**STATE OF HAWAII  
DEPARTMENT OF TRANSPORTATION  
HIGHWAYS DIVISION**

**ADDENDUM NO. 3  
for  
KUHIO HIGHWAY SHORT-TERM IMPROVEMENTS  
KUAMOO ROAD TO TEMPORARY KAPAA BYPASS ROAD  
DISTRICT OF KAWAIHAU  
ISLAND OF KAUAI**

**FEDERAL-AID PROJECT NO. NH-056-1(50)**

ADDENDUM NO. 3  
11/14/19

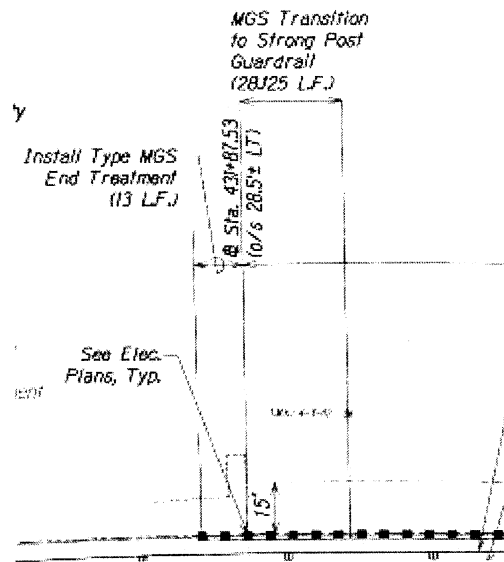
2. Is this the trailing end MGS end treatment? See picture

Yes.

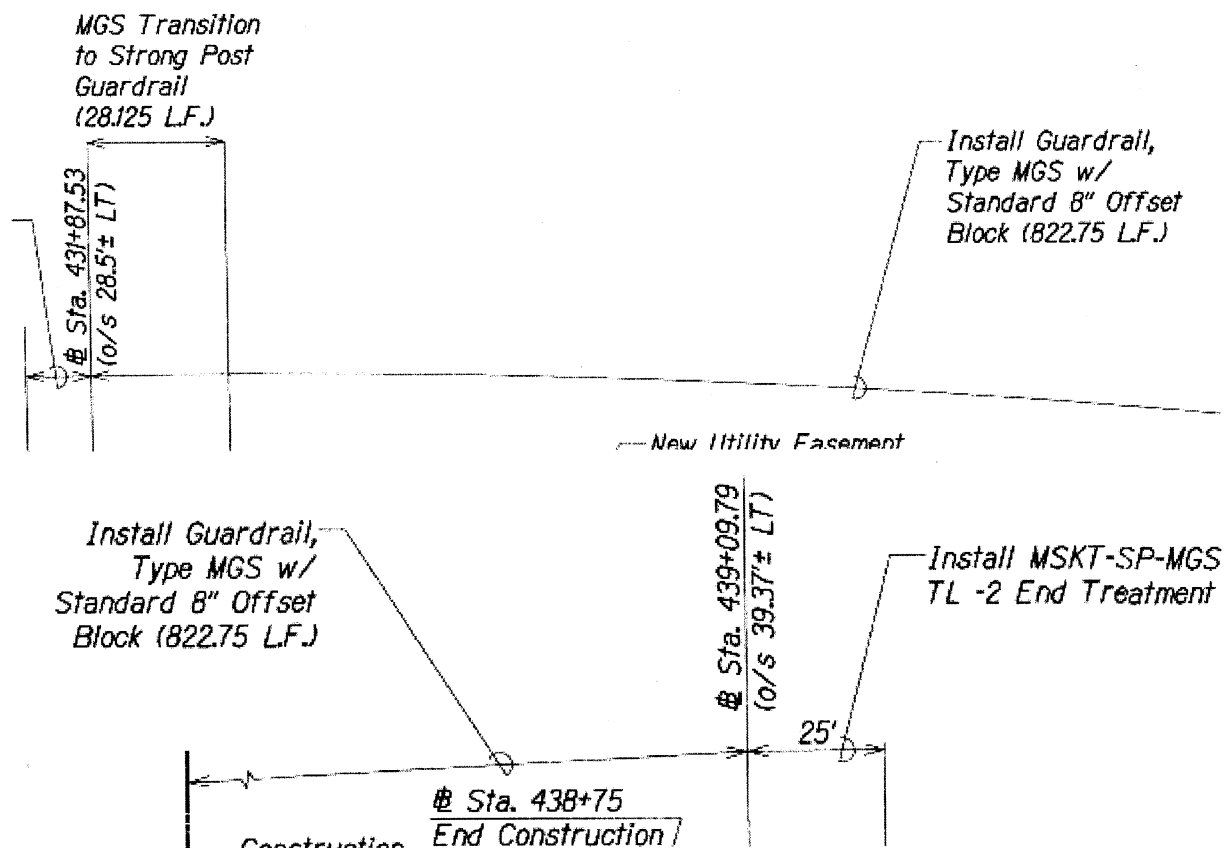
3. On Sheet 31, If the end treatment is MGS type end treatment, is the transition section required?

**No transition required. The plan sheet will be revised.**

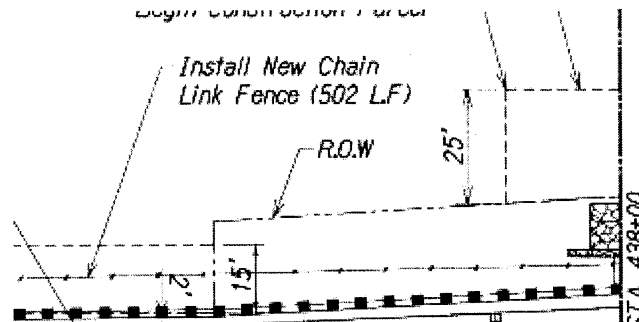
4. On sheets 31, 32 and 33 for the GR Type MGS has a length of 822.75 LF, but the stations provided does not come out to same length 722.26.

**Plan sheets will be revised to correct guardrail lengths.**

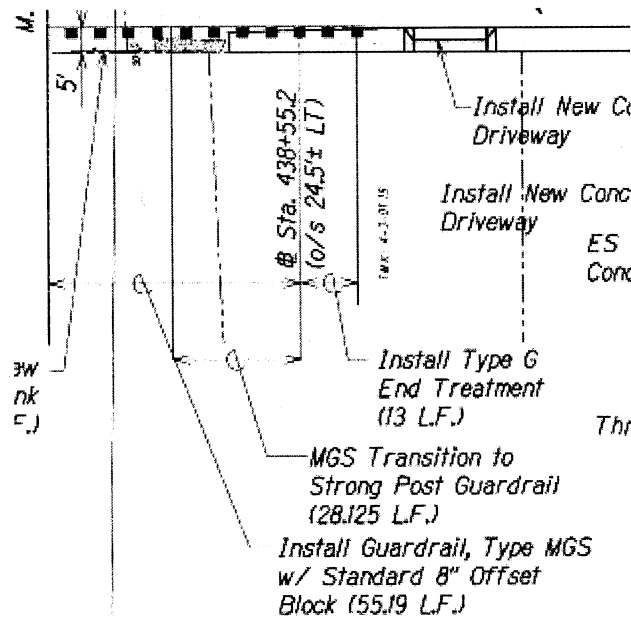
5. On sheet 32 & 33 there is call out for Chain Link Fence. Can you please provide a detail for the fence to be installed?

**Refer to HDOT's Standard Plans Chain Link Fence detail.**

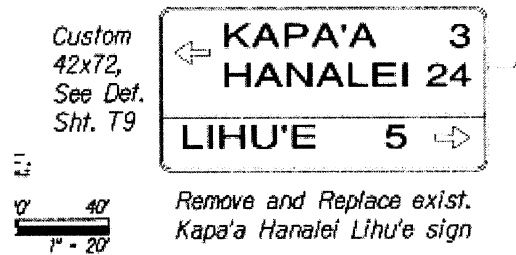
6. On sheet 33 there is a call out for transition section, there is no pay item for transition section.

**No transition required. The plan sheet will be revised.**

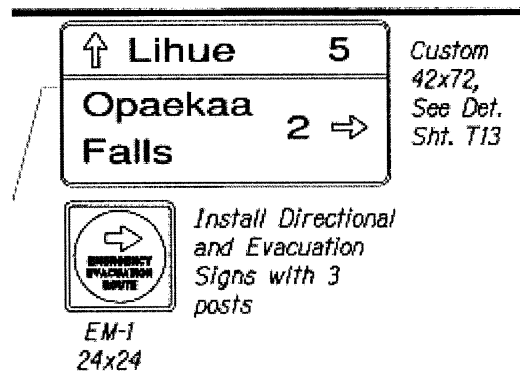
9. On sheet 67 there is a call out for a destination sign, what type of posts and footings are to be used? Can you please provide a post and footing detail?

**Refer to HDOT's Standard Plans Traffic Sign details.**

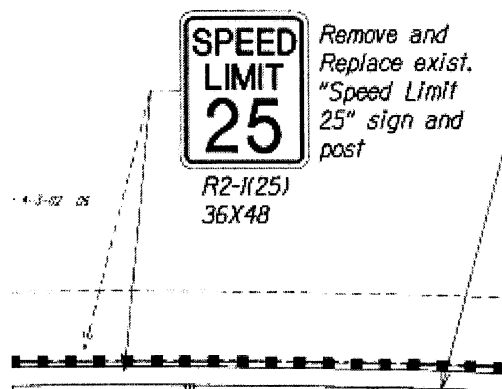
10. On sheet 68 there is a call out for a destination sign, what type of posts and footings are to be used? Can you please provide a post and footing detail?

**Refer to HDOT's Standard Plans Traffic Sign details.**

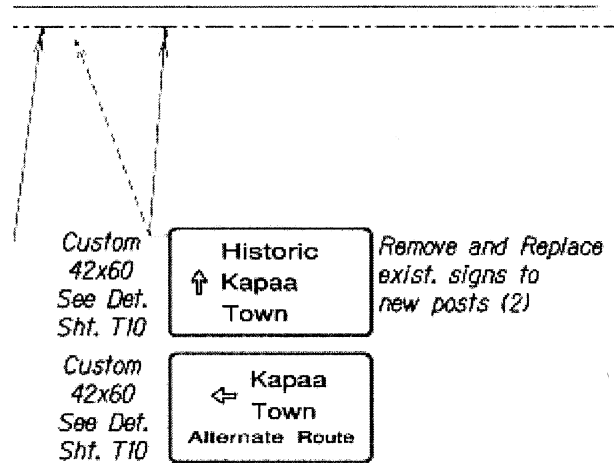
11. On sheet 72 there is a typical call out for Remove and Replace exist. "Speed Limit 25" sign and post. Can you please clarify if this typical call out means "remove and replace with new sign and new post" or "remove and reinstall existing sign on new or used post".

**Contractor to install new sign and new post.**

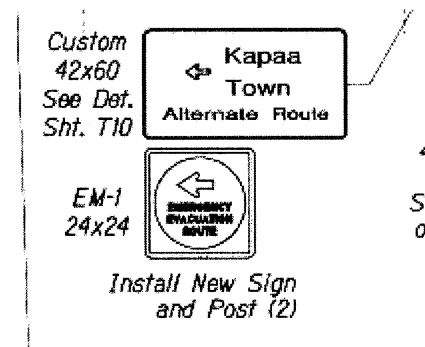
12. On sheet 73 there is a call out for a destination sign, what type of posts and footings are to be used? Can you please provide a post and footing detail?

**Refer to HDOT's Standard Plans Traffic Sign details.**

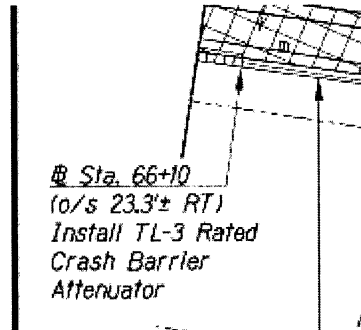
13. On sheet 74 there is a call out for a destination sign, what type of posts and footings are to be used? Can you please provide a post and footing detail?

**Refer to HDOT's Standard Plans Traffic Sign details.**

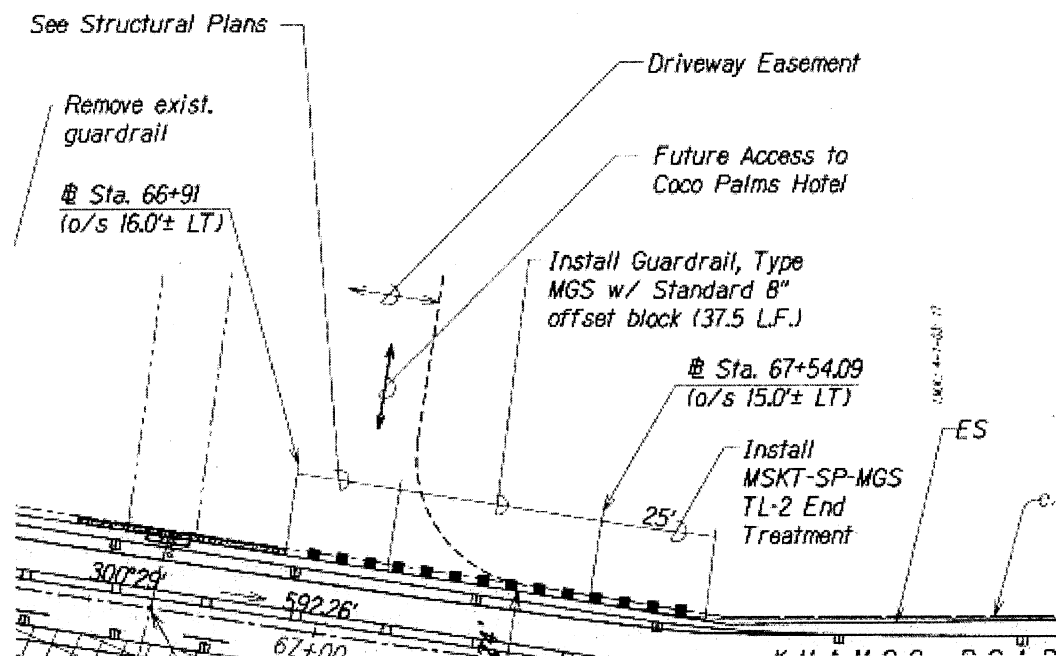
14. On sheet 77 at STA 66+10 there is a call out for Crash Barrier Attenuator. There is no pay item for this in the 693 section. Does this unit need to be MASH approved? What width does this unit need to be?

**No, unit does not need to be MASH approved. The attenuator must be wide enough to shield a Type 4A concrete barrier.**
